Product Change Notification

Change Notification #: 113290 - 00
Change Title: Intel® Server System R2312GZ4GC4
PCN 113290-00, Product Design
Update the System Rear Panel, Resistors and
Capacitors
Date of Publication: October 15, 2014

Figure One

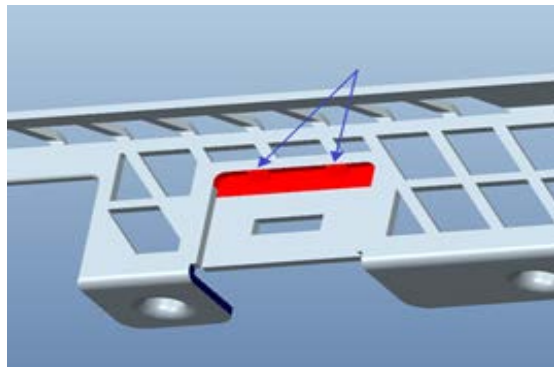
1. Update the one big center joint to two smaller joints so that the joints will not conflict with the LAN cable connector latch. See the Figure One.

Figure Two

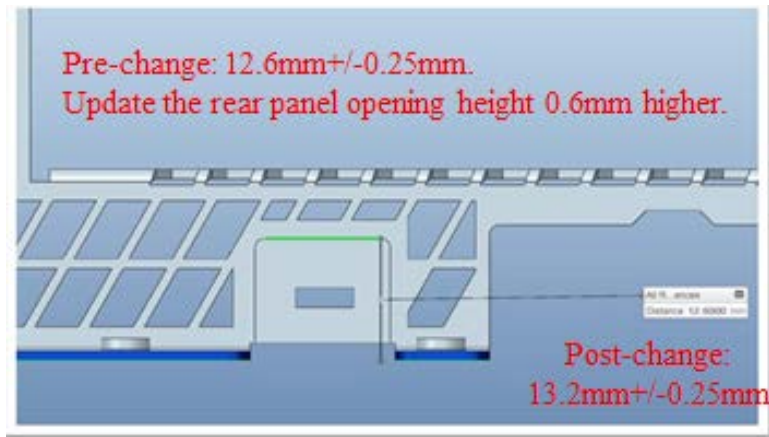
2. Update the rear panel opening height 0.6mm higher to improve the flexibility for the cable latch. The previous height was 12.6mm \pm 0.25mm. The updated height is 13.2mm \pm 0.25mm. See the Figure Two.

Figure Three

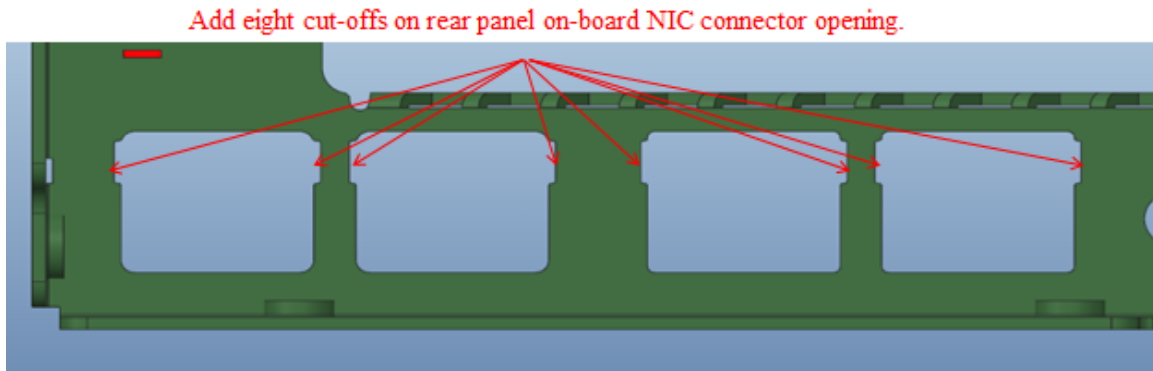
3. Add eight cut-offs around the on-board NIC (Network Interface Controller) openings to improve the LED visibility. See the Figure Three.

Figure Four. Component Locations for the 2U Riser Spare A2UL8RISER

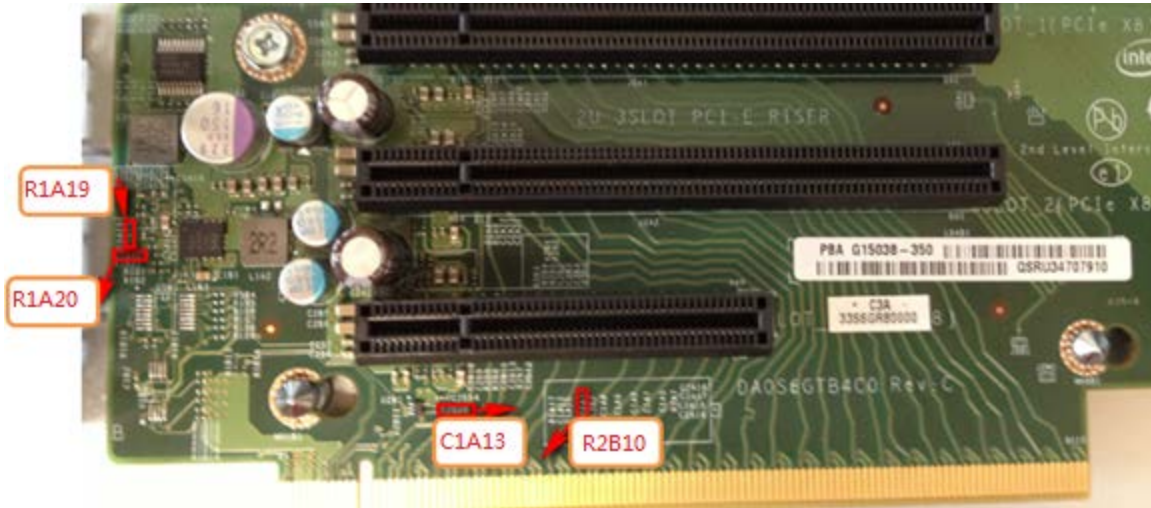
4. Update the following resistors and capacitor (see Table One and Figure Four) on the 2U PCIe Riser Spare A2UL8RISER to make an improvement to support a higher 3.3 Voltage Regulator startup over current. Before this change, the Voltage Regulator on the riser card may not be able to turn on when the total current drawn is more than 5A current. After this change, the Voltage Regulator on the riser card can support more than 10A current.
